**IN THE MATTER OF A PERMIT APPLICATION (AP-5873) FROM MEDICINE BOW FUEL & POWER, LLC TO CONSTRUCT AN UNDERGROUND COAL MINE AND INDUSTRIAL GASIFICATION AND LIQUEFACTION PLANT TO BE KNOWN AS THE MEDICINE BOW IGL PLANT**

**DECISION**

Figure 1: Modeled Annual PM-10 Increment (% consumed)

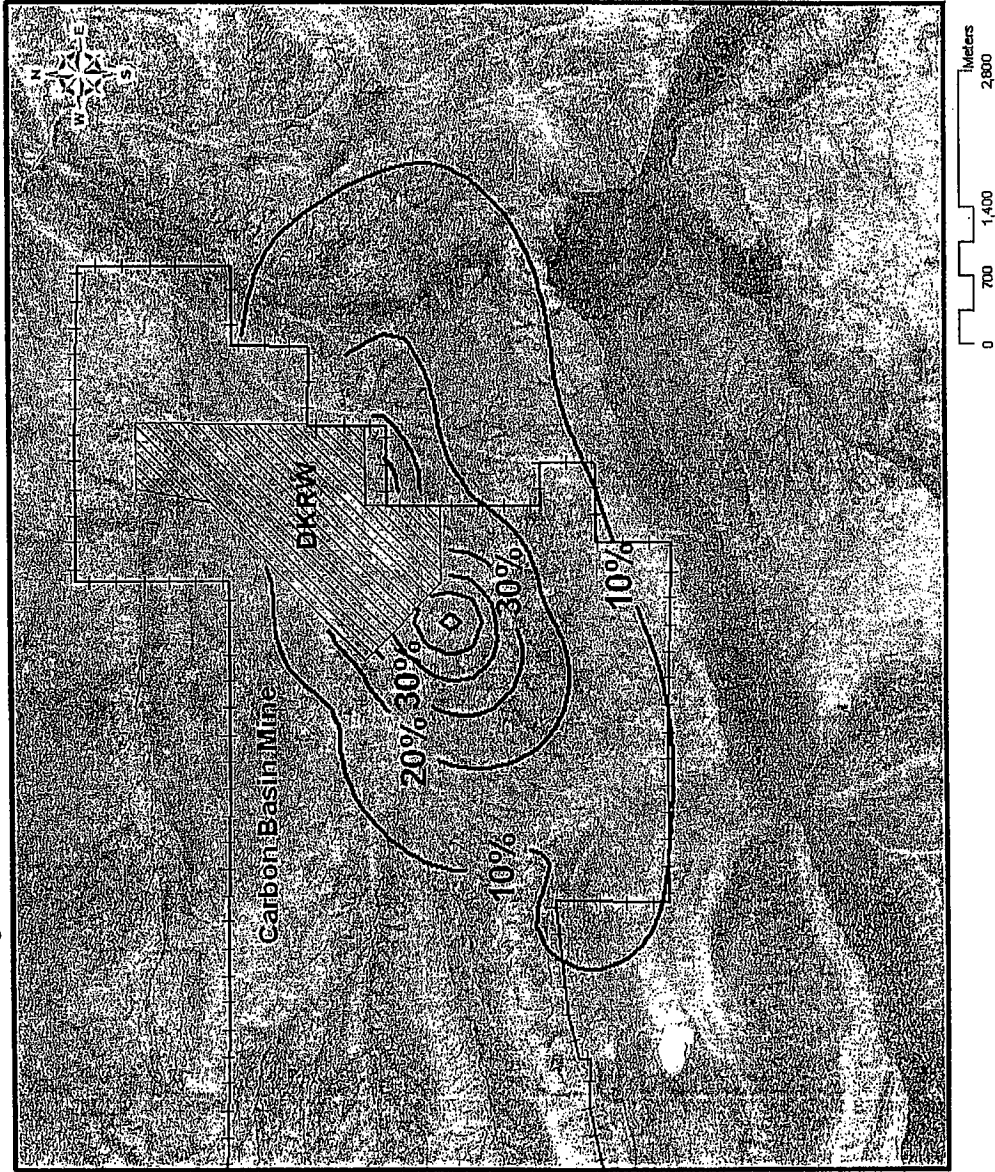
II.15 **Allowed particulate matter** – An individual commented that the plant will contribute up to 85% of the allowed particulate matter for the area, and raised several related questions:

**Response** – Emission controls for the project will consist of best available control technology (BACT). The Division's modeling analysis showed that 85% of the allowable PSD increment for PM<sub>10</sub> for the annual averaging period would be consumed near the proposed plant. The PSD increments are set at levels well below the NAAQS, and are designed to prevent newer sources from degrading the air quality in areas that attain the NAAQS. The area of relatively high increment consumption (> 50% of allowable level) is limited to an area on the western edge of the proposed facility boundary, which is contained within the boundary of the Carbon Basin Mine and not within the area considered "ambient" air available for public access. The extent of the modeled increment consumption is shown in Figure 1.

**Response** – The projected increment consumption was modeled with the proposed IGL plant sources and other nearby sources such as the neighboring coal mine, and therefore the current increment consumption (pre-IGL plant) was not considered. The results of the modeling indicate that the proposed facility will not prevent the attainment or maintenance of any air quality standard. The modeling domain did not extend to the Medicine Bow National Forest, which is located approximately 18-km to the southeast of the proposed project. The area of relatively high (> 50% of allowable level) increment consumption is predicted for an area at the west end of the boundary for the proposed project (see Figure 1).
